**CITY OF KELOWNA****MEMORANDUM**

Date: July 25, 2017
File No.: Z17-0055
To: Urban Planning (AC)
From: Development Engineering Manager (JK)
Subject: 1655 Dilworth Drive Zone: I1 to I2, I3

Date: July 25, 2017
File No.: S17-0057
To: Community Planning (AC)
From: Development Engineering Manager (JK)
Subject: 1655 Dliworth Drive

1 Site Plan
1 : 360

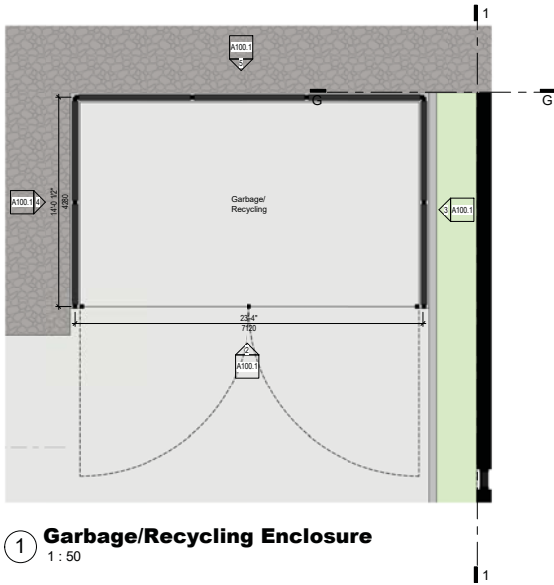
- (i) Access to the site does not meet the throat length requirement of 15 m as laid out by TAC standard.
- (ii) A MSU standard size vehicle must be able to manoeuvre onto and off the site without requiring a reverse movement onto public roadways. If the development plan intends to accommodate larger vehicles movements should also be illustrated on the site plan.
- (iii) Perimeter access must comply with the BC Building Code. Fire Truck access designs and proposed hydrant locations will be reviewed by the Fire Protection Officer.
- (iv) The future, access and egress to the site may be restricted to right-in and right-out onto Enterprise Way with a future median.
